City of Suffolk HISTORIC LANDMARKS COMMISSION

November 8, 2018

Re: REQUEST FOR CERTIFICATE OF APPROPRIATENESS HLC2018-00025,

Subject: REQUEST FOR CERTIFICATE OF APPROPRIATENESS HLC2018-

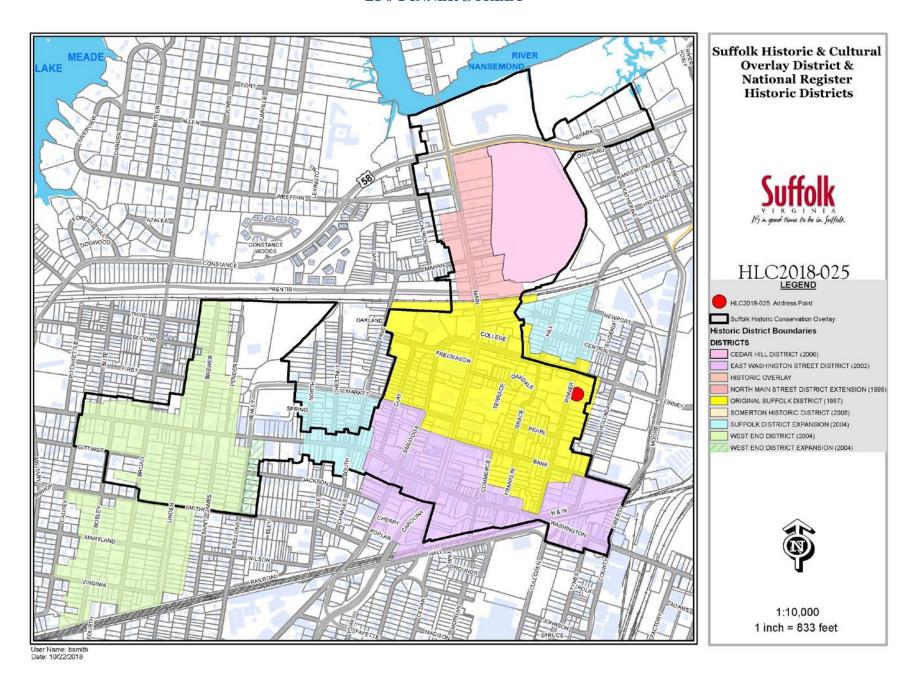
The applicant proposes to replace a previously existing covered porch with a screened porch to be located on the east side of the proposed addition. The porch will share a roof with the addition and will feature treated wood posts to be painted black, charcoal colored screen, and a decorative wooden screen door that will also be painted black. Wooden stairs to access the porch are also proposed to be painted black.

The Guidelines acknowledge that rear porches tend to be utilitarian, and the proposed location of this porch will limit its visibility from the street and its visual impact on the District. The form and materials proposed are generally appropriate to the District with the exception of the block foundation, which should be faced in red brick to match the house.

- 1. Construct a single story frame addition at the rear (east side) of the property utilizing the following materials:
 - Roof Gable, GAF Timberline Natural Shadow architectural shingles in charcoal
 - Siding Carolina Beaded vinyl siding to match house
 - Rear door Steel JELD-WEN French patio door with interior blinds, in white
 - Windows Two Pella ThermaStar 6/6 double hung vinyl windows, in white
 - Foundation Concrete block with red face brick to match house
- 2. Construct a screened porch on the east side of the proposed addition utilizing the following materials:
 - Roof Gable, GAF Timberline Natural Shadow architectural shingles in charcoal
 - Posts 6x6 treated wood, to be painted black
 - Screen Charcoal in color
 - Door Springview decorative wooden screen door, to be painted black to match posts
 - Foundation Concrete block with red face brick to match house

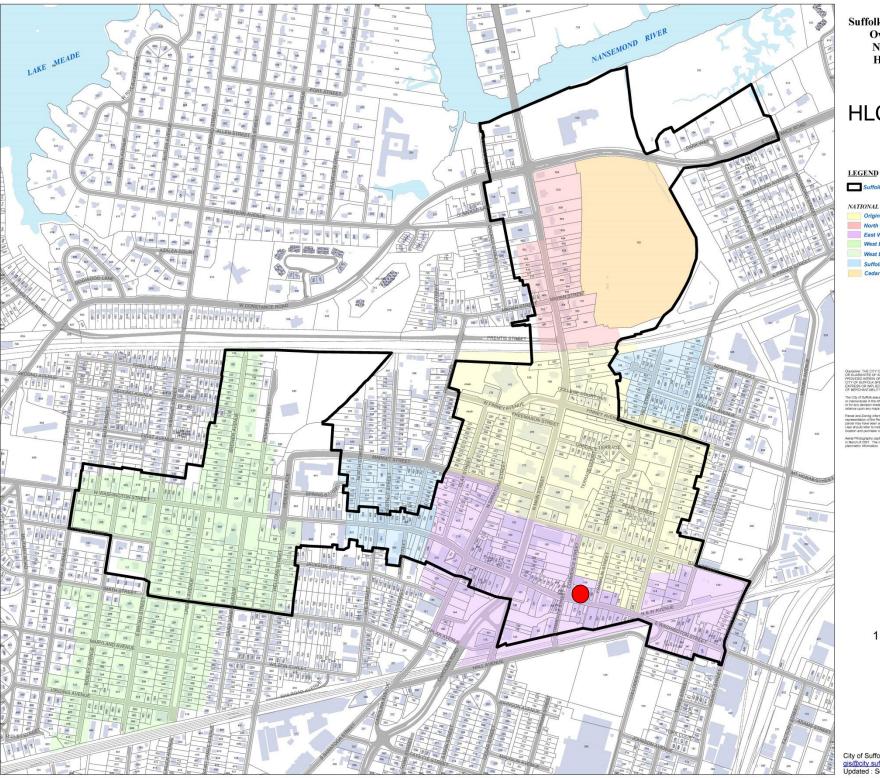
The last component of this request includes the after-the-fact approval of a 19' x 22' covered patio that has been constructed at the rear of the building of pressure treated, unpainted wood. The structure includes a flat TPO (Thermoplastic Polyolefin) membrane roof that is not visible from the public right-of-way. Additionally, the covered patio has a metal gutter and one downspout, both white in color. The rear elevation does not have any public street frontage, however; it does abut a City owned parking lot and is visible from Franklin Street, which is located approximately 80' from where the covered patio has been constructed.

Chapter 1, Section F. of The Historic District Design Guidelines state that "Additions and alterations to buildings require careful design in order to preserve and strengthen the character of the district." Specifically, attention should be given to what types of materials are used on additions to ensure that they are compatible with the traditional materials of which historic buildings are composed. Mercantile buildings in the district primarily consist of brick structures with wood trim and metal accents. While wood is an appropriate accent, it should not be a primary building material on commercial buildings, as is the case with the covered patio that has been constructed. Additionally, Chapter 4, Section F.2.b. of the Guidelines state that wood features in the historic district should be kept primed and painted, which the covered patio is not. Furthermore, the wood used in the construction of the patio is inconsistent with the type of material that would have been used on commercial patio areas in the district. Unpainted pressure treated wood, as used in the construction of the covered patio, is typical of more modern, suburban residential construction and is inappropriate on contributing commercial structures. A combination of brick and metal with creative cover options, such as shade sails or other cloth materials, would be more appropriate to create a covered patio area.

In July of 2017, the Historic Landmarks Commission approved an outdoor seating area for the Brick and Mortar Brewing Company that is located a block from the building in question. The approved Certificate of Appropriateness resulted in a covered patio with painted steel columns with brick veneer bases and an overhead shade system consisting of steel cables and sail cloth shades. A covered patio consisting of materials similar to the approval described above would be appropriate to the structure and the district as the covered patio that has been constructed does not align with the standards identified within the District Guidelines.

- 1. Install a 55 square foot internally illuminated sign on the front of the building.
- 2. Install a 2 ½ square foot window sign on the front entry door of the building.
- 3. Install a 6 square foot window sign and a 8 ½ square foot sign on the windows of the front elevation of the building.
- 4. Install a 2 ½ square foot window sign on the rear entry door of the building.
- 5. Install a 418 square foot wood covered patio on the rear of the building.
